Van Zandt County, Texas Communications Tower Infrastructure RFP

RFP ADDENDUM NUMBER 1

Release Date: July 14, 2023

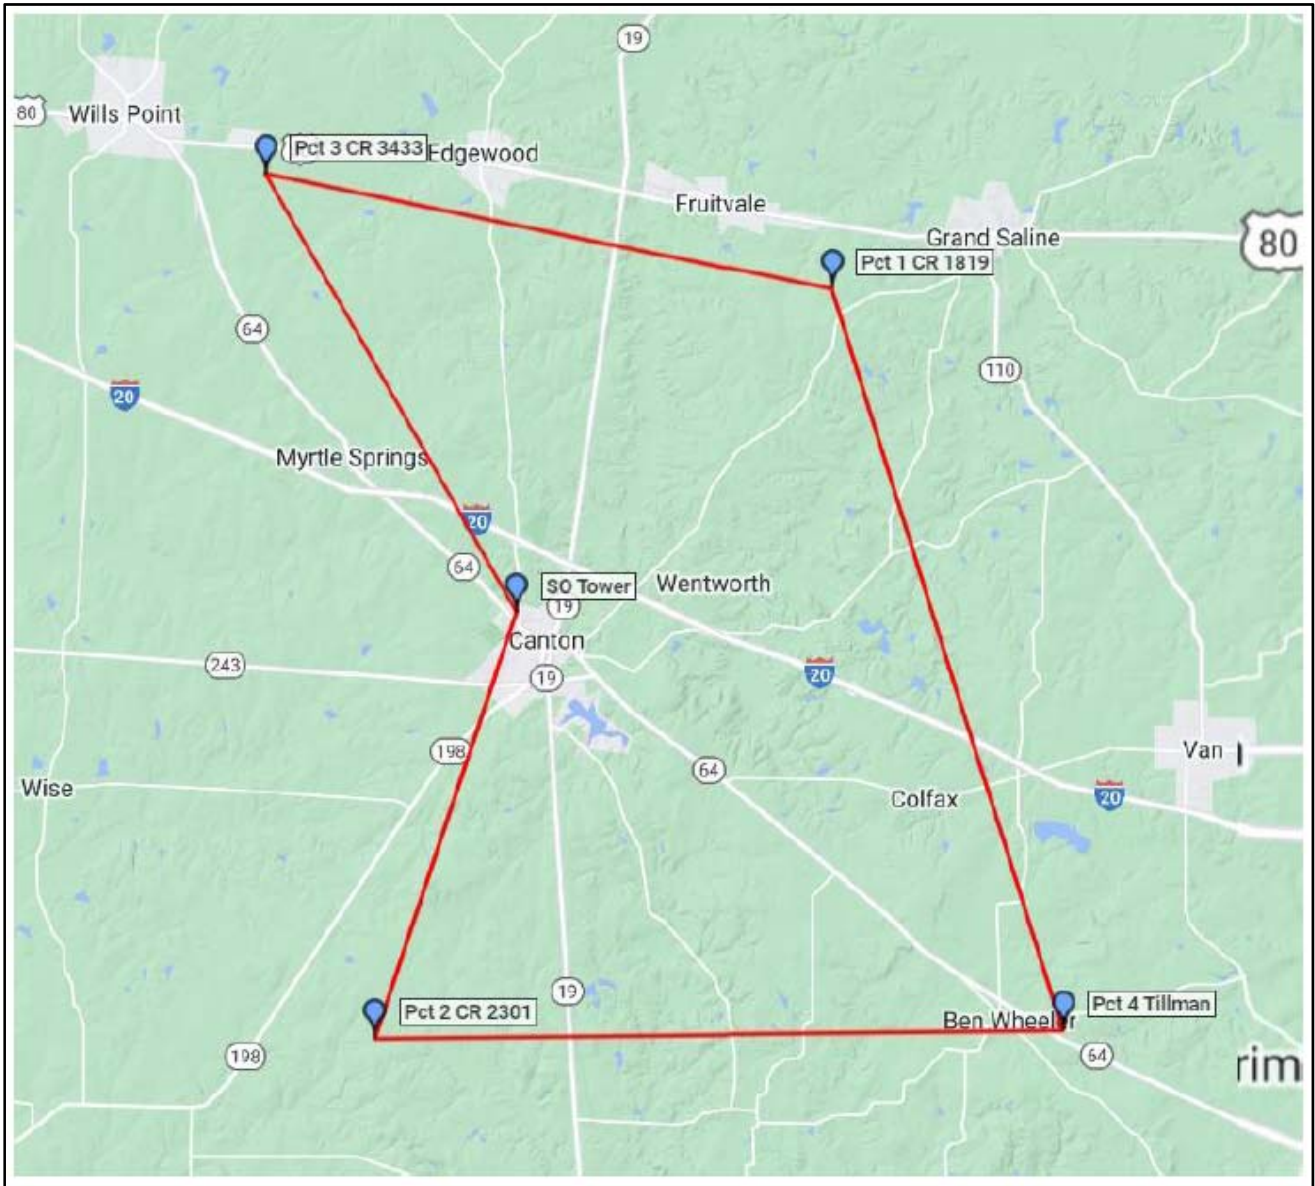
Question 3: 3.8.8 Van Zandt County P25 Installation Specifications

Table 4 in the RFP contains the County’s backhaul microwave antenna installation details for each site. Table 4 does not specify the transmitting azimuths of the proposed microwave dishes at each site. Please provide the azimuths for the microwave dishes for each tower?

Answer: The map and table provided below depict and denote the azimuths for each of the microwave dishes that comprise the backhaul design for the County’s P25 radio system. Two six foot microwave dishes will be installed on each tower site to create the backhaul ring depicted on the map.

TRUE / MAGNETIC AZIMUTHS					
	Site A		Site B		
Site Name	True	Magnetic	Magnetic	True	Site Name
Pct 1 CR 1819	163	161	341	343	Pct 4 Tillman
Pct 2 CR 2301	89	87	267	269	Pct 4 Tillman
Pct 2 CR 2301	18	16	196	198	SO Tower
Pct 3 CR 3433	102	100	280	282	Pct 1 CR 1819
Pct 3 CR 3433	150	148	328	330	SO Tower
